PRE-APPLICATION COMMENT SUMMARY LETTER

SUBJECT: Summary of Comments and Questions
Major Development Pre-Application Public Workshop on September 25, 2025
480 Avenue Alhambra, El Granada, CA 94019
APNs: 047-251-100, 047-251-110, and 047-262-010
County File Number: PRE2025-00033

Subject: ***Pre-Application PRE2025-00033 (Granada Community Park and Recreation Center Project)***

Subject: Snapshot
Page Label: 16
Author: scai1
Date: 9/16/2025 1:45:05 PM
Color:

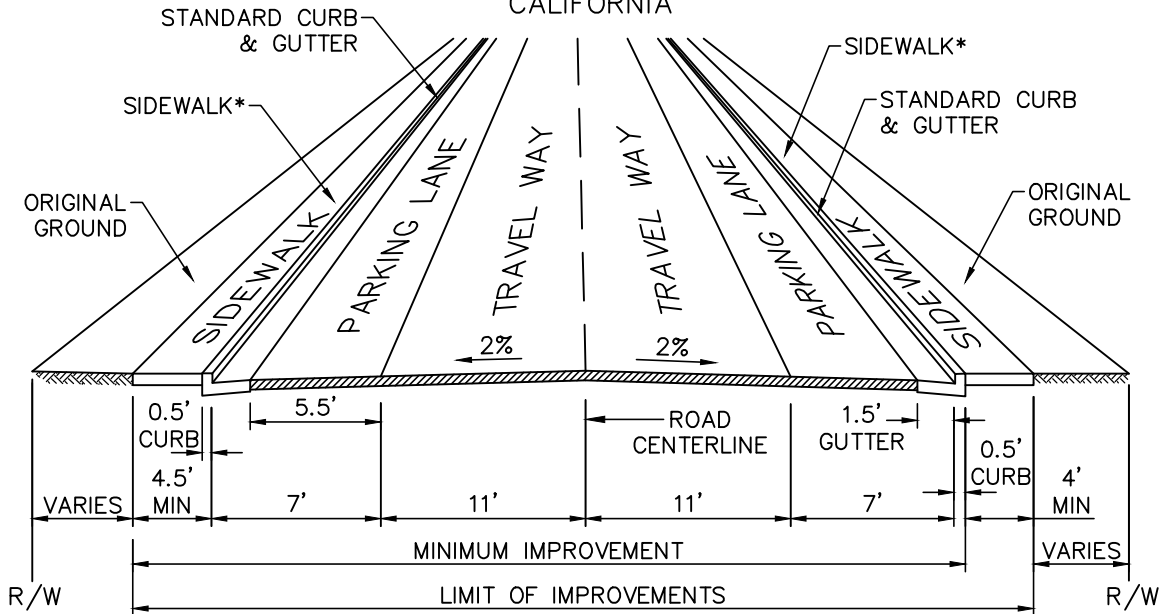
El Granada road standards require 22' paved travel way, parking lane, curb, gutter, and sidewalk. See attached detail
